Proposed Revisions to a Standard Plans Index

Index Number: 700-030

Index Title: Wind and Hanger Beams for Overhead Signs

Added New General Note 1 - "Meet requirements of Specification 700."; Deleted Notes 6 and 7; Renumbered Notes;
Updated General Note references in the TYPICAL SIGN FOR OVERHEAD TRUSS details.

TYPICAL SIGN FOR OVERHEAD TRUSS

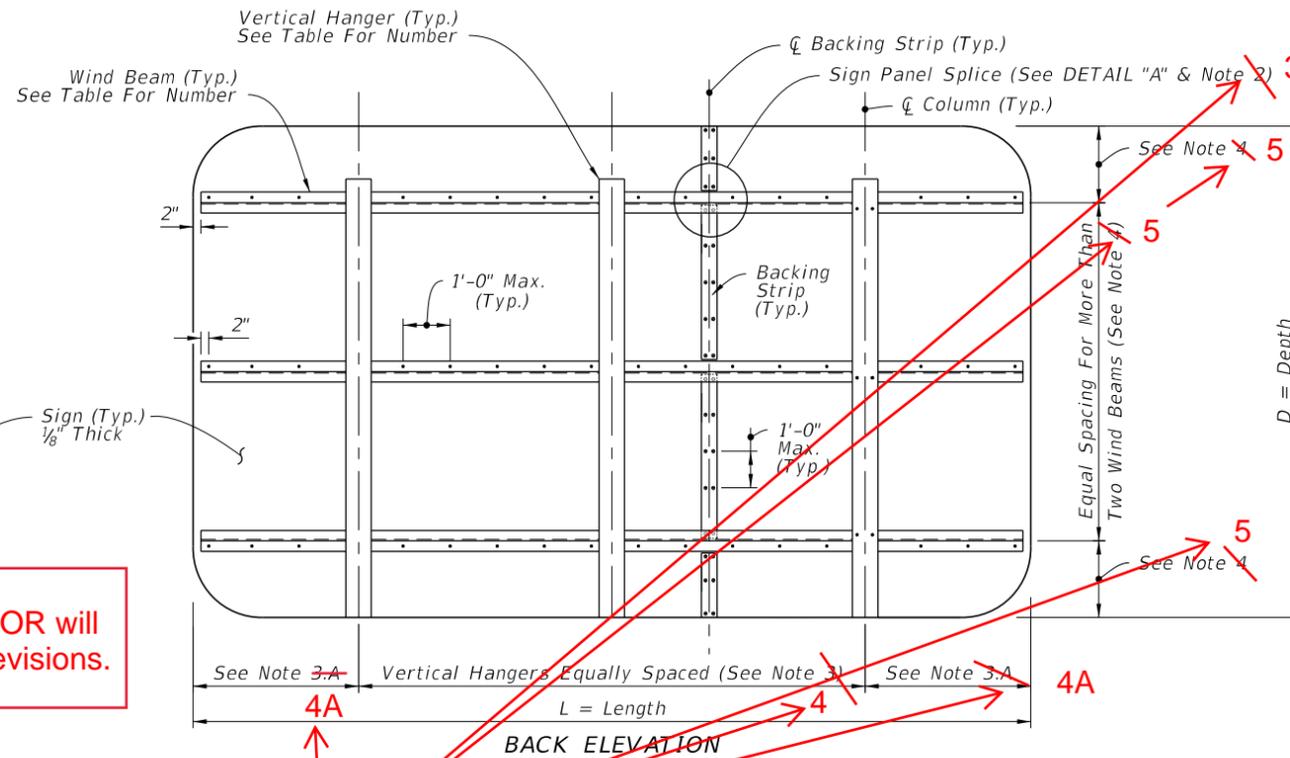
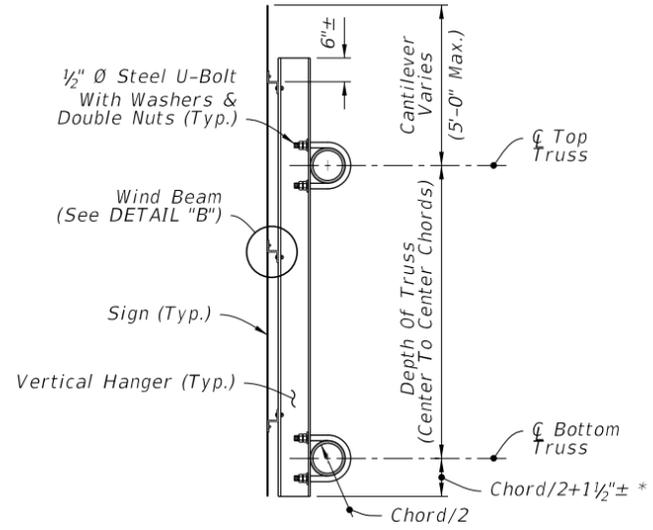
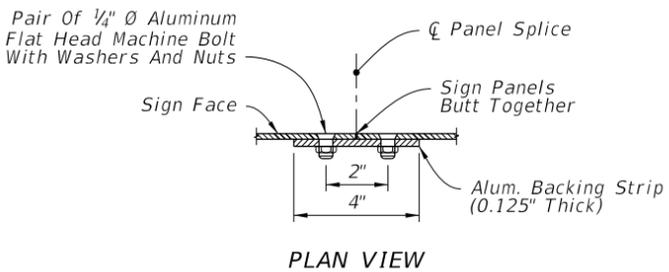
GENERAL COMMENT: Some material information was deleted. Information is either already covered in Standard Specifications OR will be added to Section 700, 962 or 965 in conjunction with these revisions.

UPDATED: References (See General Note...)

ADDED NEW NOTE 1: Meet the requirements of Specification 700.

DELETED NOTES

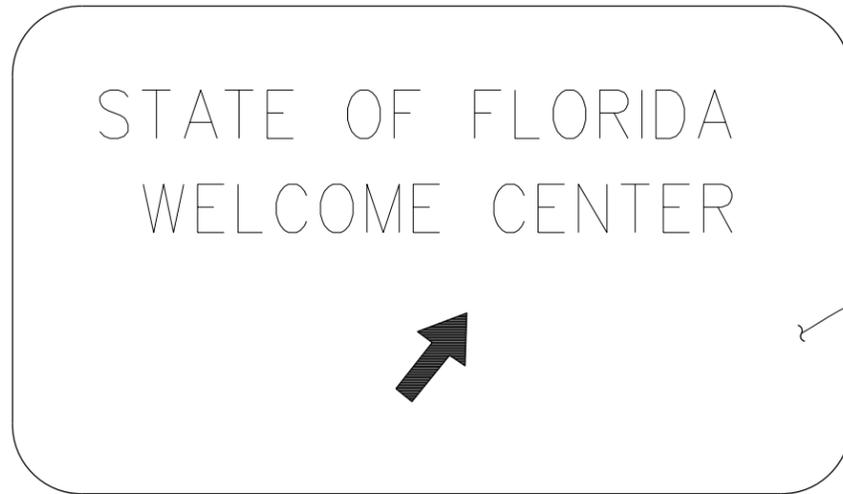
6. Materials:
 - A. Aluminum:
 - a. Bars and Extruded Shapes: ASTM B221, Alloy 6061-T6 or Alloy 6351-T5
 - b. Structural Shapes: ASTM B221, Alloy 6061-T6
 - c. Flat Head and Hex Head Machine Bolts: ASTM F468, Alloy 2024-T4

- d. Hex Nuts: ASTM F467, Alloy 6061-T6 or Alloy 6262-T9
 - e. Washers: ASTM B221, Alclad 2024-T4
 - B. Steel:
 - a. U-Bolts: ASTM A449 or ASTM A193 B7
 - b. Nuts: ASTM A563, 2 per leg

- c. Washers: ASTM F436, (Flat Washers)
7. Coatings:
 - A. Aluminum Bolts, Nuts and Washers: Anodic (0.0002 inches min) and chromate sealed.
 - B. Galvanized Steel Bolts, Nuts and Washers: ASTM F2320
